Township of Gloucester
Zoning Board of Adjustment
Wednesday, October 25, 2017
7:00 P.M.

Agenda

TOWNSHIP OF GLOUCESTER
Inter-office Correspondence

RE: **APPLICATION #172051C**
Robert Speese
405 Station Avenue
BLOCK 801, LOT 23

N° 105 STATION AVENUE
TOWNSHIP OF GLOUCESTER
CAMDEN Co. New Jersey
Scale — 1" = 15'
609-662-0356
303-70

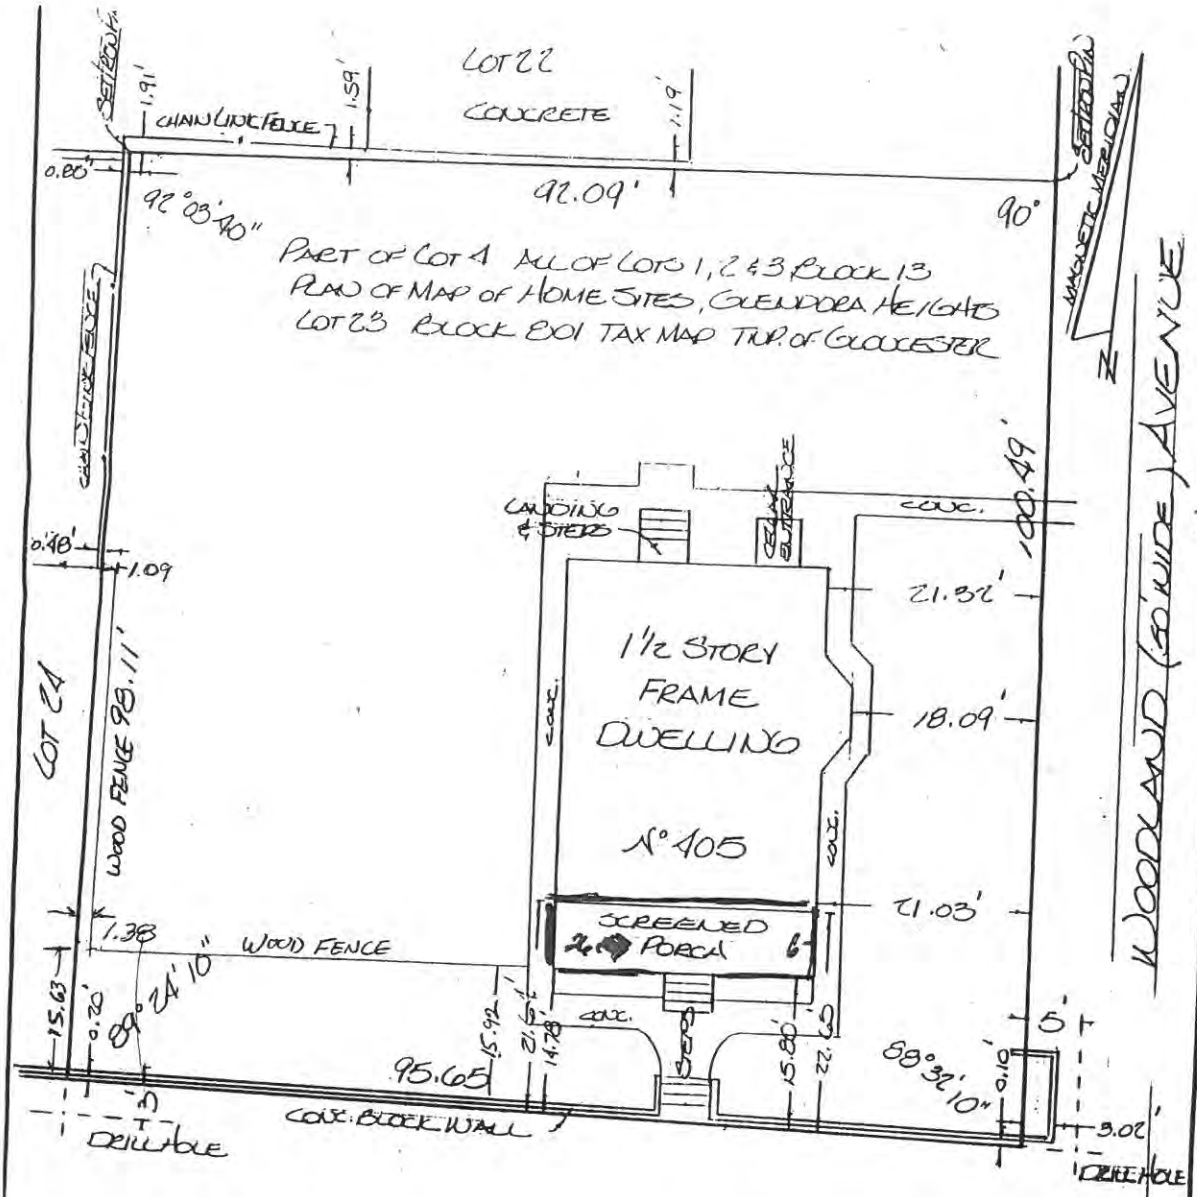
1. Front yard: (14.78 ft. provided v. 20 ft. minimum required).

From Section 406.F, Area, Yard, Height and Building Coverage to permit a front porch fourteen and seventy eight hundredths (14.78) feet from the front property line along Station Avenue (20 ft. minimum required).

Comments on Decision:
Porch is to be located a minimum of 20' from the front property line. A Variance approval is required prior to issuance of permit.

FRONT ELEVATION

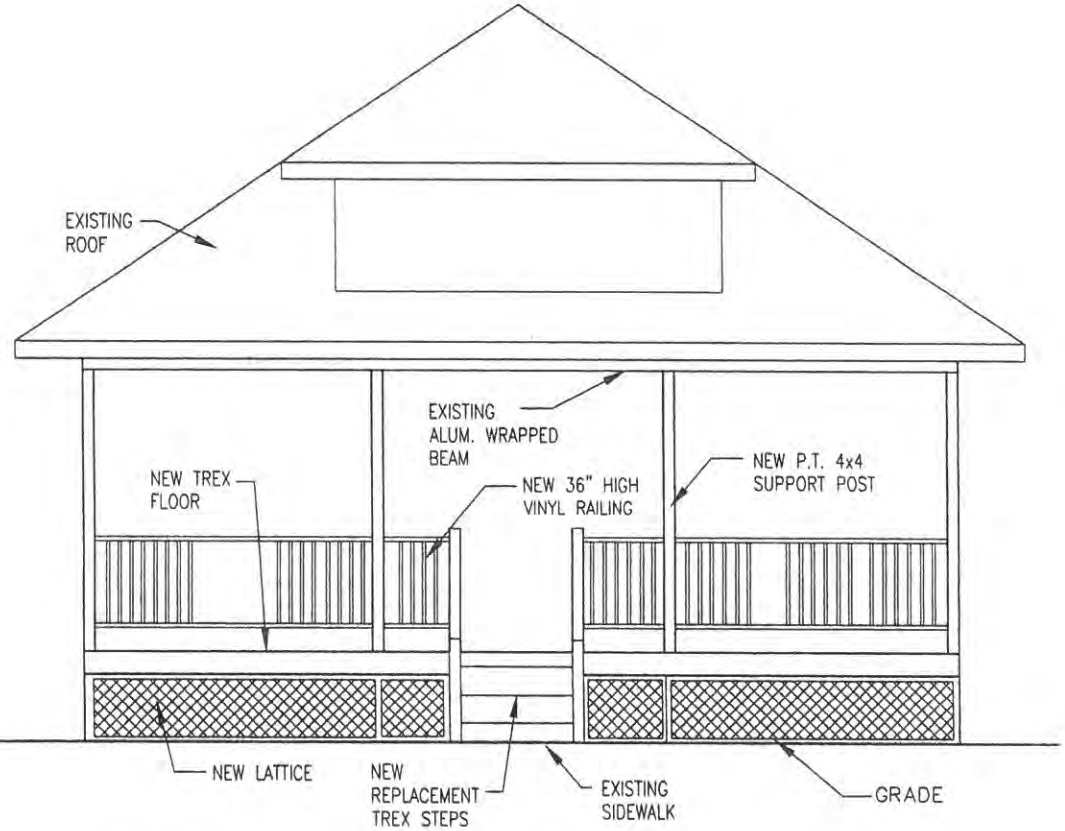
The above application is to permit a 6' x 26' front porch within the R-4 - Residential district as per the submitted sketch.

Property Plan

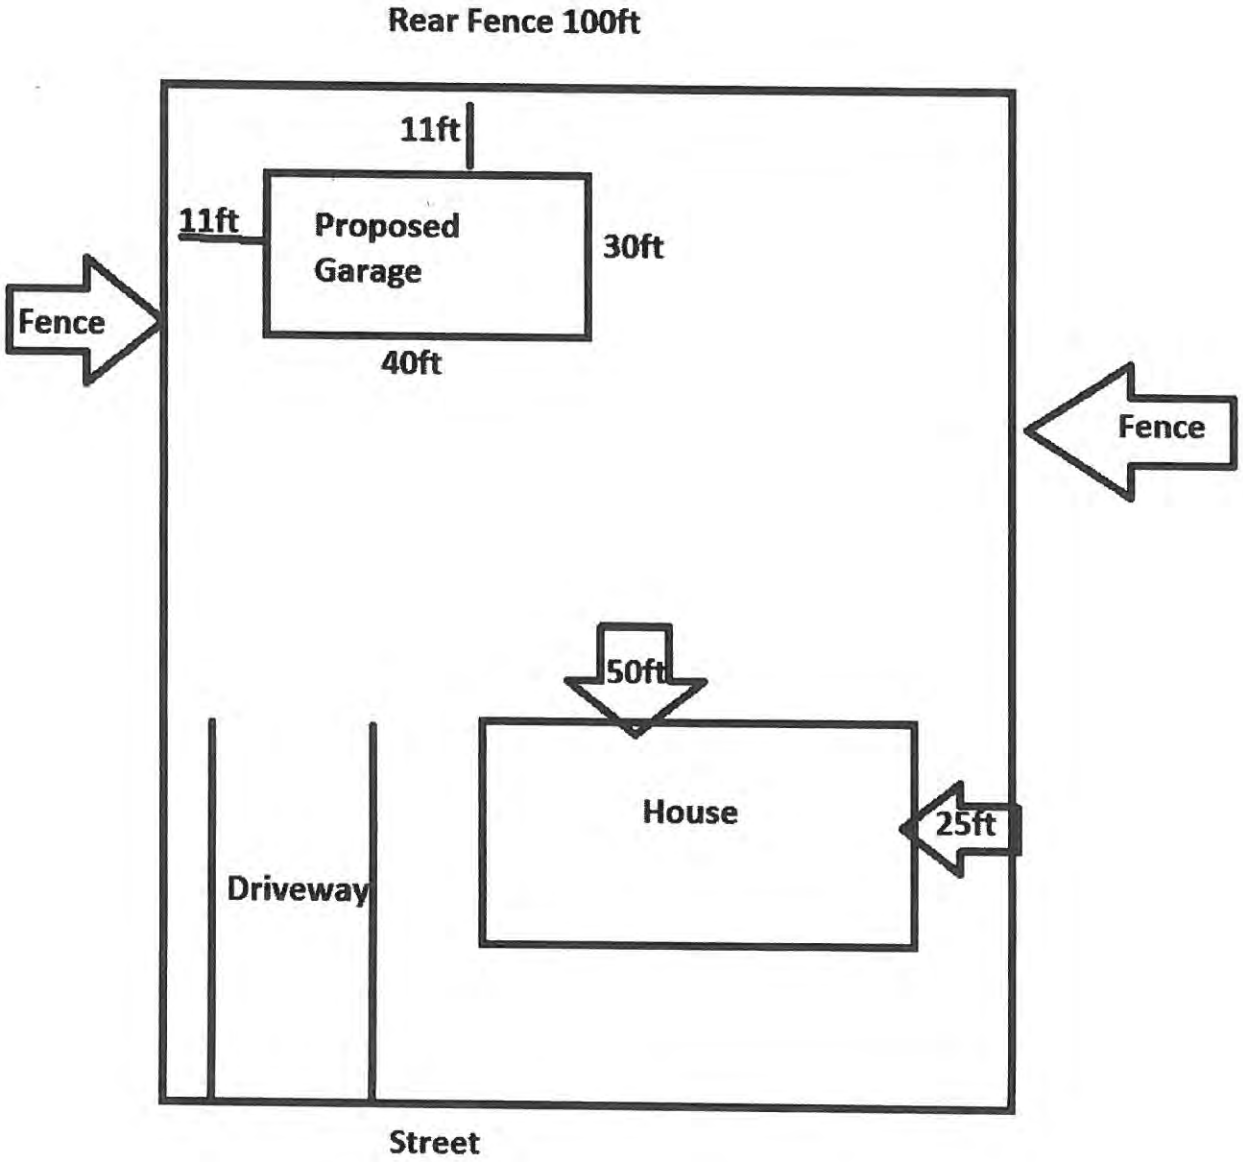
The above application is to permit a 30' x 40' detached private garage with 14-foot high side walls, and 20-foot garage height within the R-3 Residential district as per the attached sketch.

1. Area: (1,200 sf. provided v. 800 sf maximum allowed).
2. Side wall height: (14 ft. provided v. 9 ft. maximum allowed).
3. Garage Height: (20 ft. provided v. 14 ft. maximum allowed).

FRONT ELEVATION - GARAGE

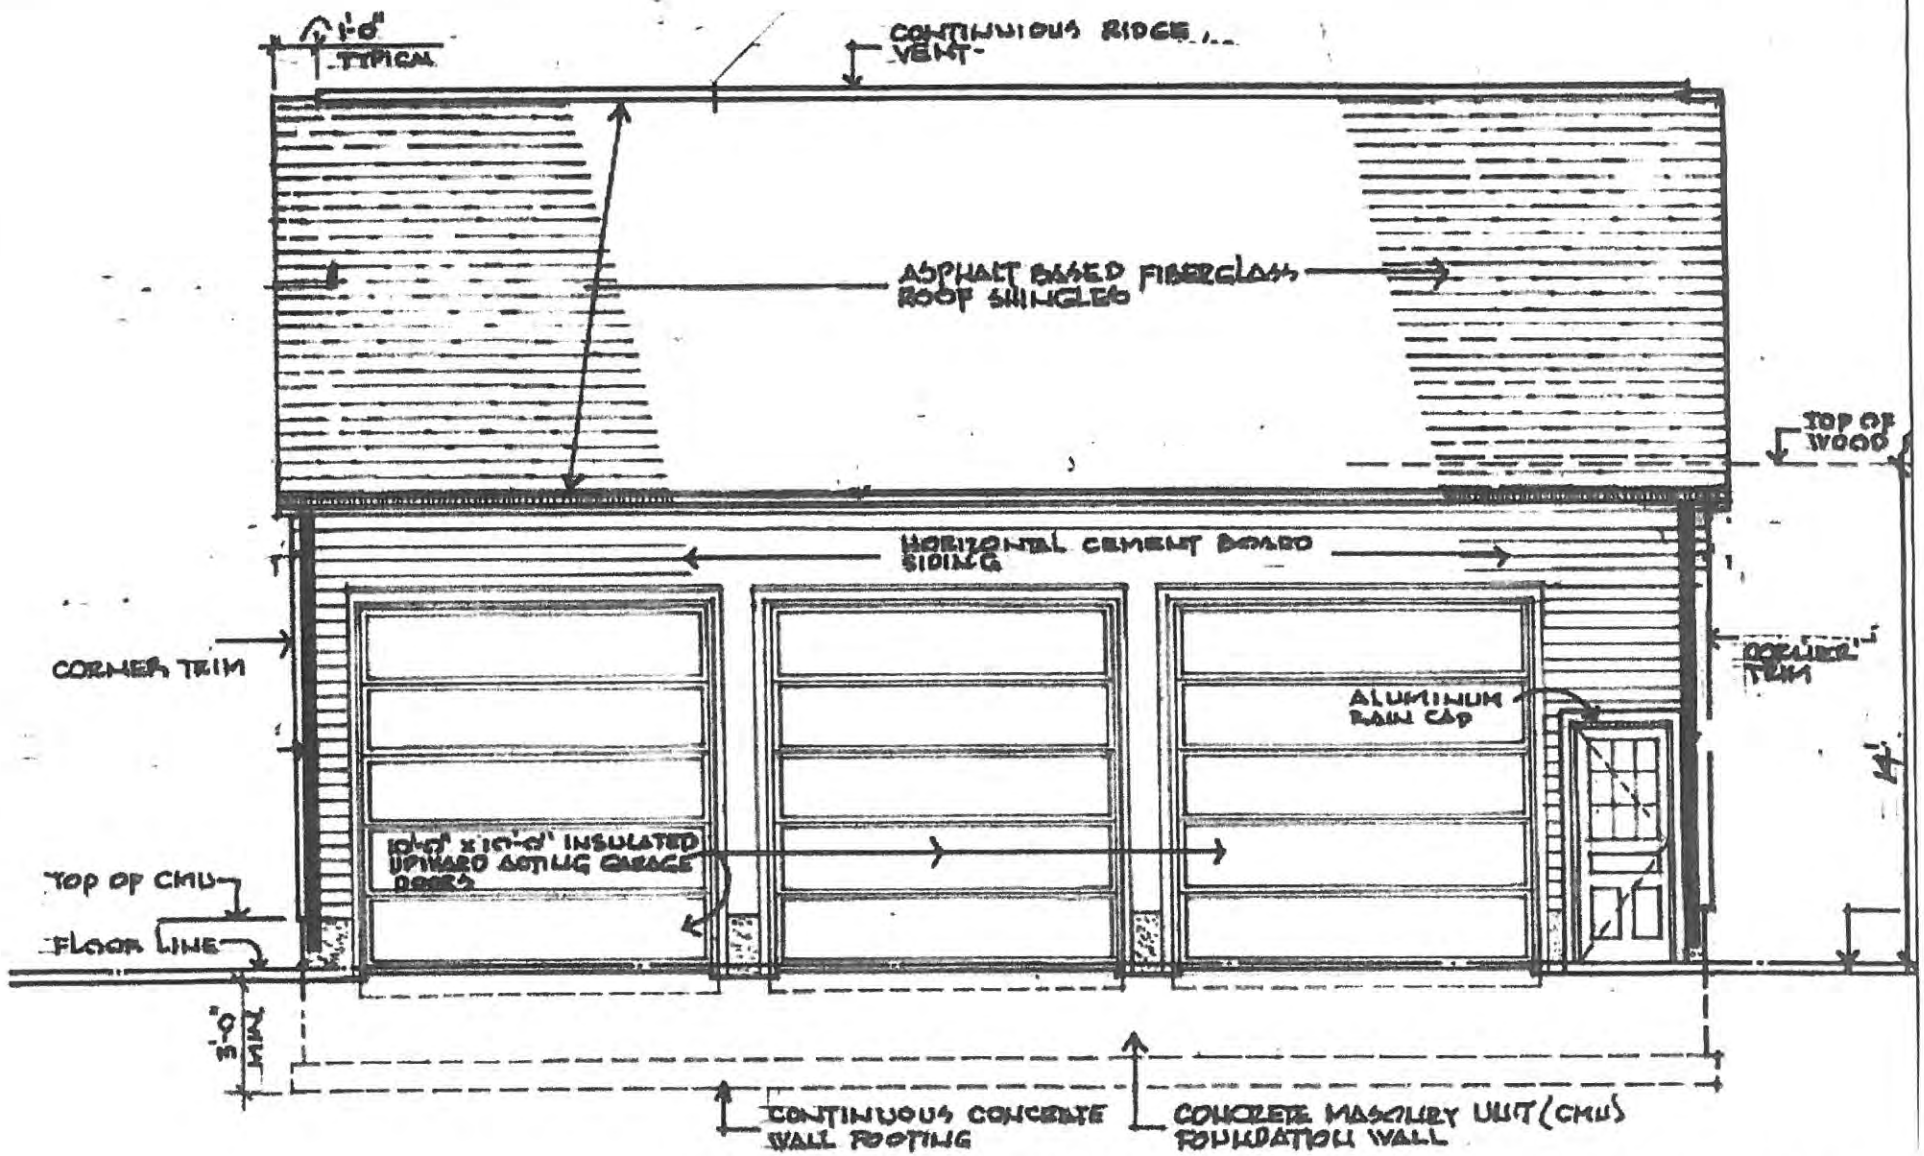
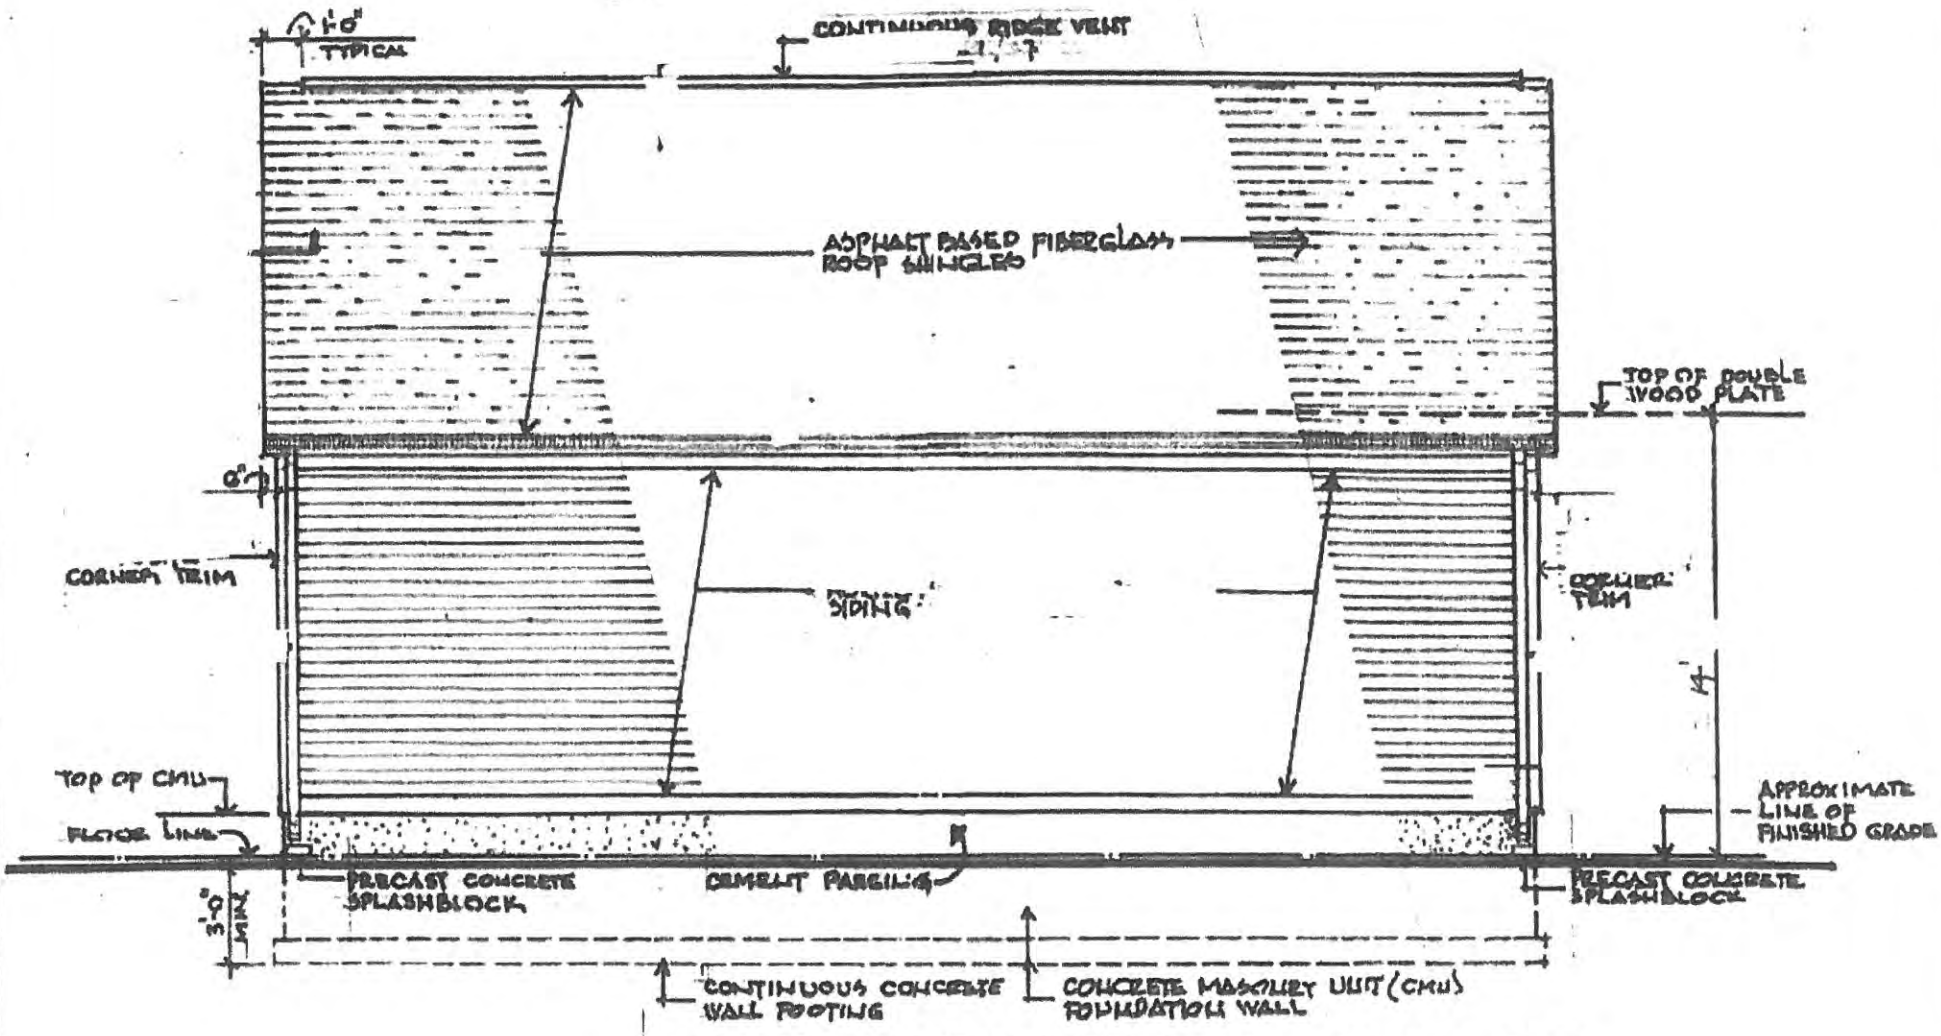
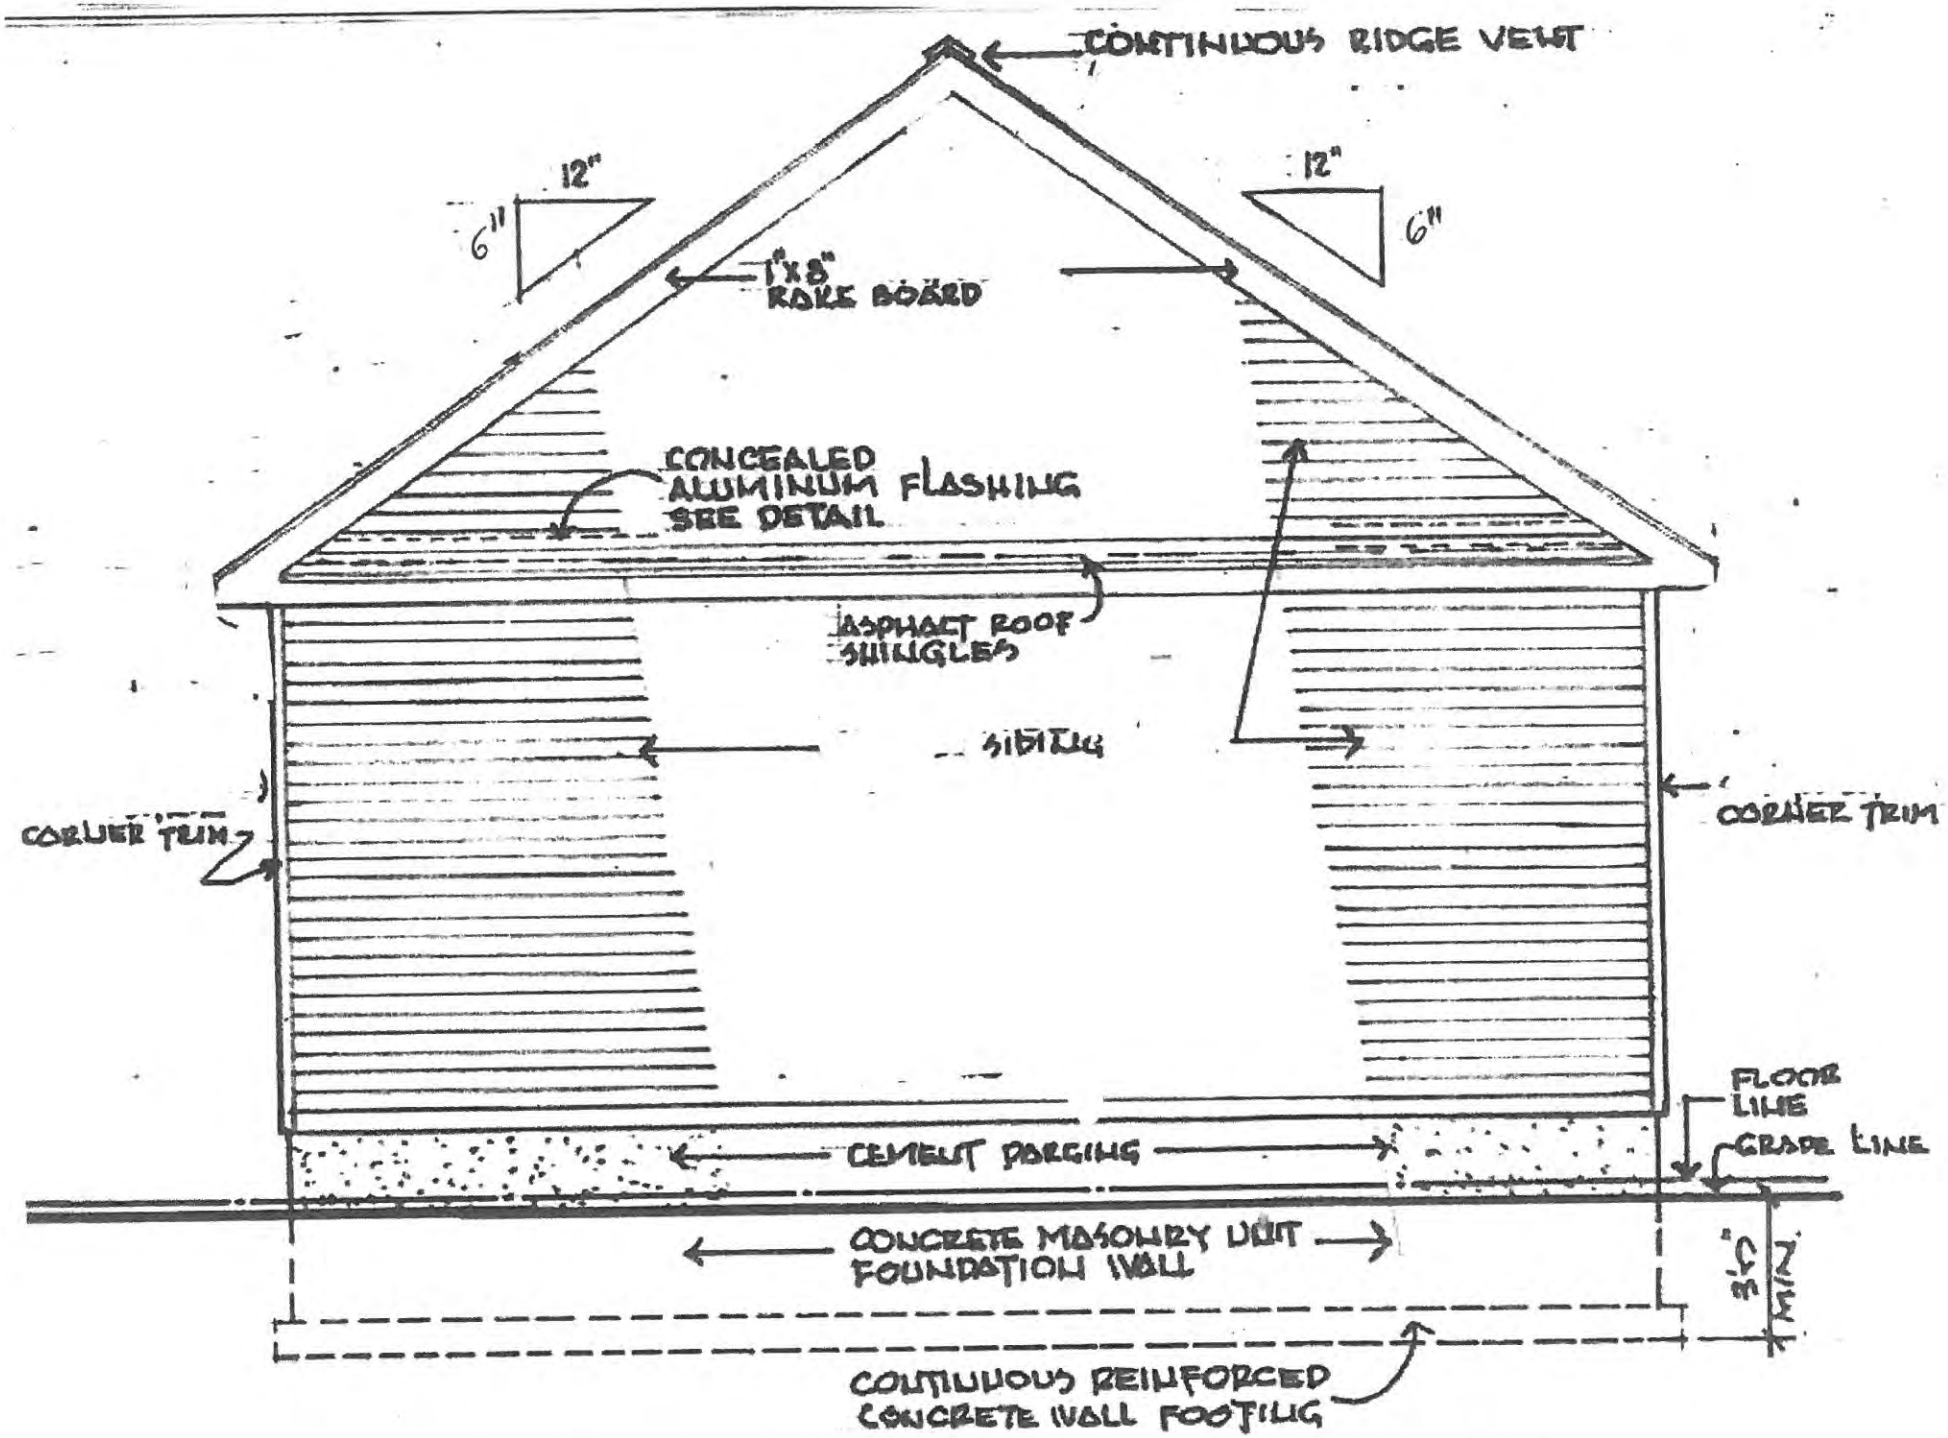
OUR RECORDS ALREADY SHOW ONE "SHED" ON PROPERTY. THIS GARAGE IS EXTREMELY LARGE FOR RESIDENTIAL AREA - HEIGHT of 22' IS WAY TOO HIGH FOR RES. AREA. COULD BE DETRIMENT TO NEIGHBORS. NEED TO CLARIFY FOR RES USE ONLY AND NO COMMERCIAL USE.
